SUBJECT: NORTH ANNA UNIT 1 - ISSUANCE OF AMENDMENT RE: HEATUP AND
COOLDOWN CURVES (TAC NO. 72060)

VIRGINIA ELECTRIC AND POWER COMPANY
OLD DOMINION ELECTRIC COOPERATIVE
DOCKET NO. 50-338
NORTH ANNA POWER STATION, UNIT NO. 1
AMENDMENT TO FACILITY OPERATING LICENSE

Amendment No. 117
License No. NPF-4

ATTACHMENT TO LICENSE AMENDMENT NO. 117

Figure 3.4.2 Reactor Coolant System Pressure-Temperature Heatup Limitations

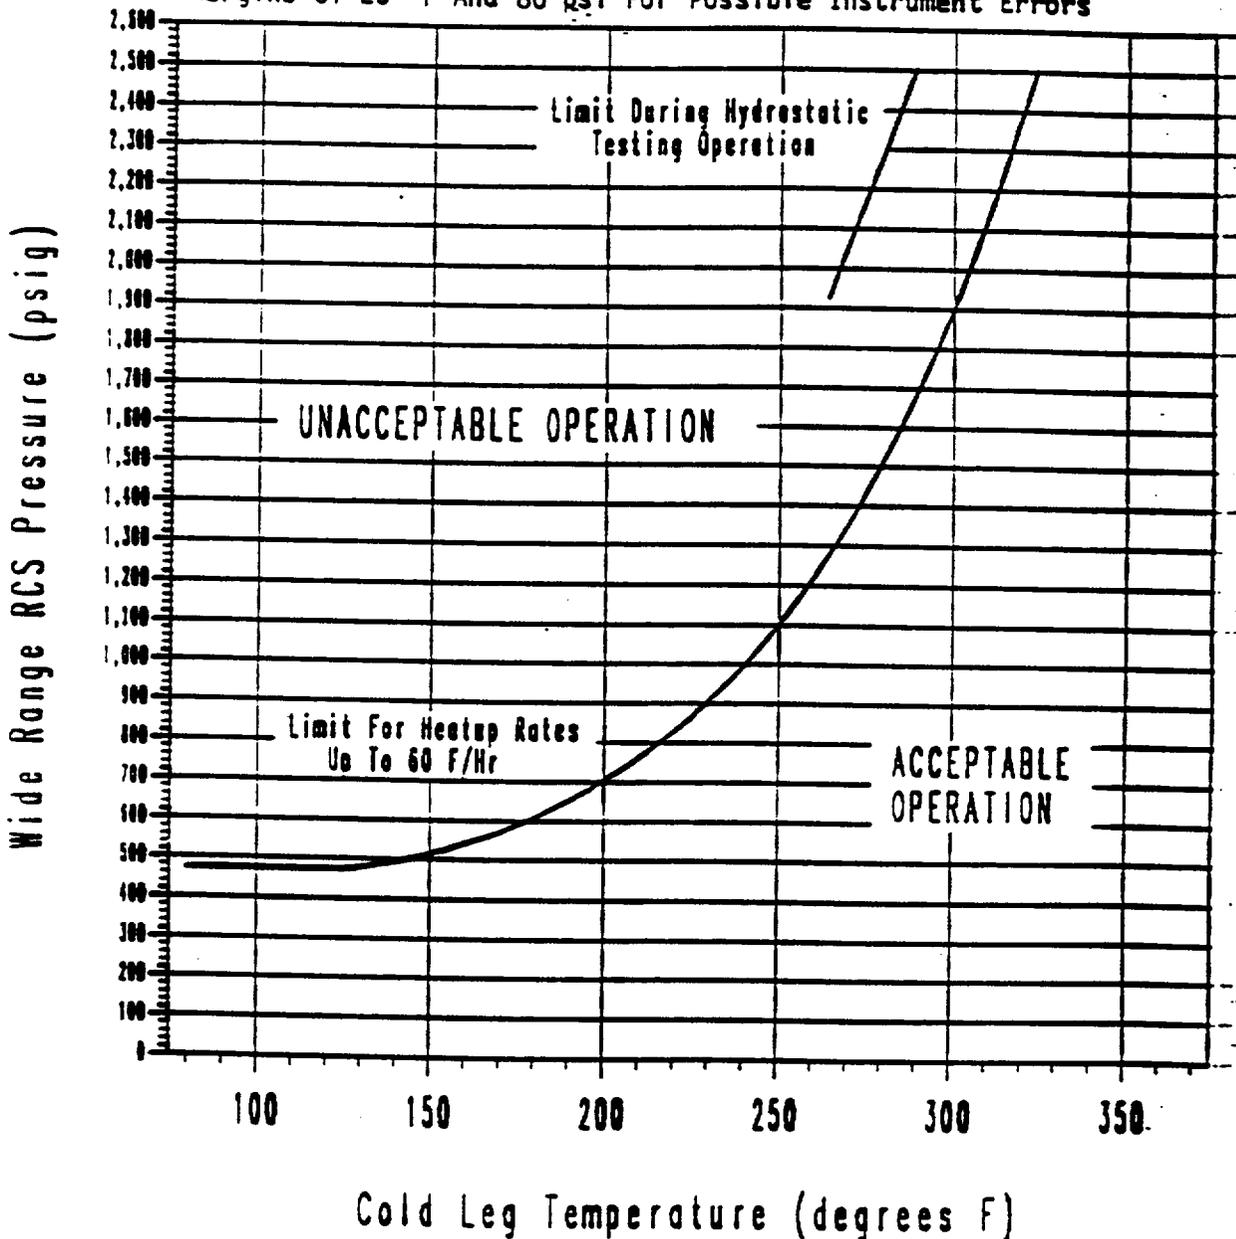
This amendment revises the heatup and cooldown curves and associated low temperature overpressurization setpoints to be valid for a period up to 10 effective full power years. In addition, the staff finds that the submittals supporting your amendment request comply with Generic Letter 88-11 and the methods specified in Regulatory Guide 1.99, Revision 2.

The heatup limit curve, Figure 3.4.2, is a composite curve which was prepared by determining the most conservative case, with either the inside or outside wall controlling, for any heatup rate up to 60°F per hour. The cooldown limit curves of Figure 3.4.3 are composite curves which were prepared based upon the same type analysis with the exception that the controlling location is always the inside wall where the cooldown thermal gradients tend to produce tensile stresses while producing compressive stresses at the outside wall. The heatup and cooldown curves were prepared based upon the most limiting value of the predicted adjusted reference temperature at the end of 10 EFPY. The adjusted reference temperature was calculated using results from a capsule removed after the sixth fuel cycle. The results are documented in Westinghouse Reports WCAP-11777, February 1988 and WCAP-11791, May 1988.

The pressure-temperature limit lines shown on Figure 3.4.2 for inservice leak and hydrostatic testing have been provided to assure compliance with the minimum temperature requirements of Appendix G to 10 CFR 50. The minimum temperature for criticality specified in T.S. 3.1.1.5 assures compliance with the criticality limits of 10 CFR 50 Appendix G.

Controlling Material: Circumferential Weld
Copper Content: 0.086 WT%
Nickel Content: 0.11 WT%
Initial RT_{NDT}: 19°F

RT_{NDT} 1/4T, 136.3 °F
3/4T, 116.1 °F

Curves Applicable For Service Periods Up To 10 EFPY And Contain Margins Of 20 °F And 80 psi For Possible Instrument Errors
